**PCN#20160823001**  
**Carrier Tape Change for select TSSOP Package Device**  
**Final Change Notification**

<b>PCN Number:</b>	20160823001	<b>PCN Date:</b>	Sept. 1, 2016
<b>Title:</b>	Carrier Tape Change for select TSSOP Package Device		
<b>Customer Contact:</b>	<a href="#">PCN Manager</a>	<b>Dept:</b>	Quality Services
<b>Proposed 1<sup>st</sup> Ship Date:</b>	Dec. 1, 2016		
<b>Change Type:</b>			
<input type="checkbox"/>	Assembly Site	<input type="checkbox"/>	Assembly Process
<input type="checkbox"/>	Design	<input type="checkbox"/>	Electrical Specification
<input type="checkbox"/>	Test Site	<input checked="" type="checkbox"/>	Packing/Shipping/Labeling
<input type="checkbox"/>	Wafer Bump Site	<input type="checkbox"/>	Wafer Bump Material
<input type="checkbox"/>	Wafer Fab Site	<input type="checkbox"/>	Wafer Fab Materials
<input type="checkbox"/>		<input type="checkbox"/>	Wafer Fab Process
<input type="checkbox"/>		<input type="checkbox"/>	Part number change

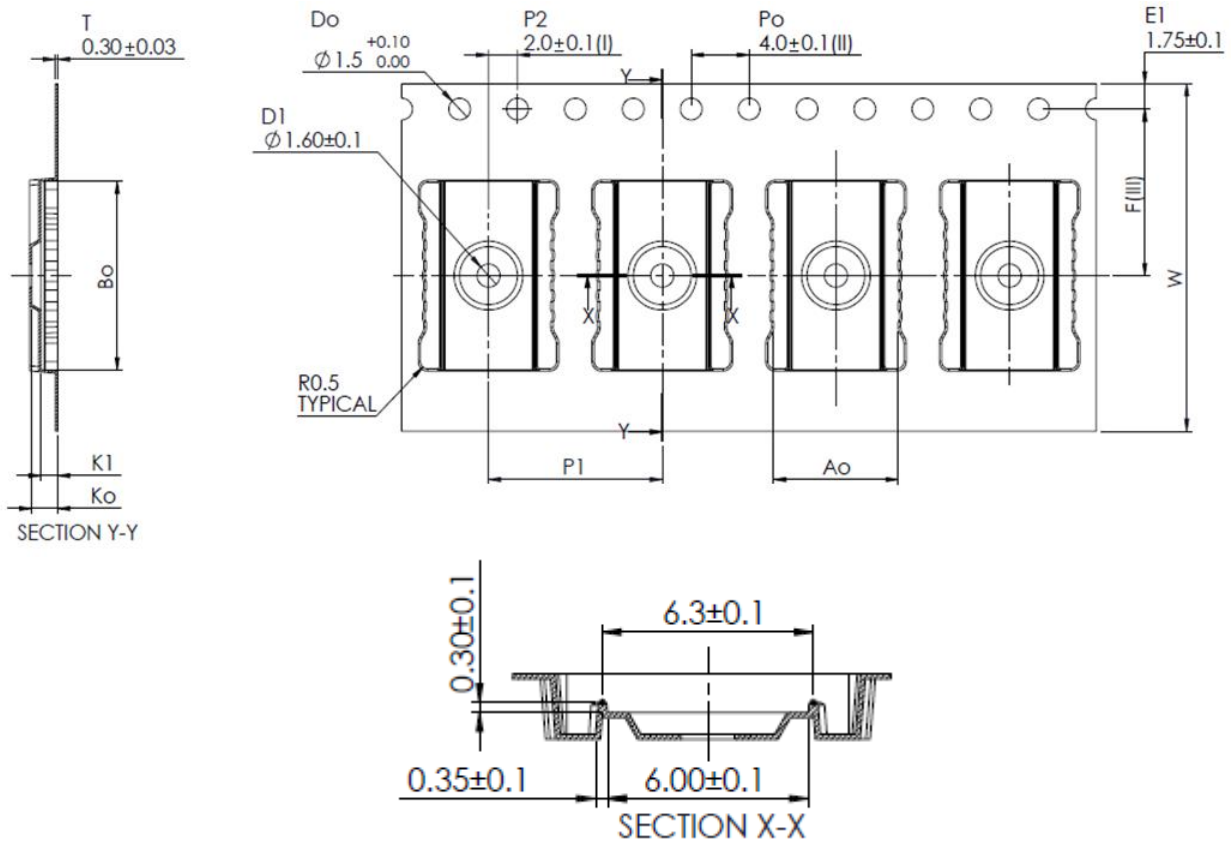
Texas Instruments is pleased to announce the qualification of a new carrier tape for select TSSOP Package Device. The material composition between the 2 carrier tapes is the same. A dimensional comparison summary is below:

Dimension	From	To
Part No.	4068850-0015	<b>4212589-0040</b>
A0	8.60 (+/- 0.1) mm	8.60 (+/- 0.1) mm
B0	15.80 (+/- 0.1) mm	<b>13.00 (+/- 0.1) mm</b>
K0	1.80 (+/- 0.1) mm	1.80 (+/- 0.1) mm
K1	1.30 (+/- 0.1) mm	<b>1.15 (+/- 0.1) mm</b>
W	24.00 (+/- 0.3) mm	24.00 (+/- 0.3) mm
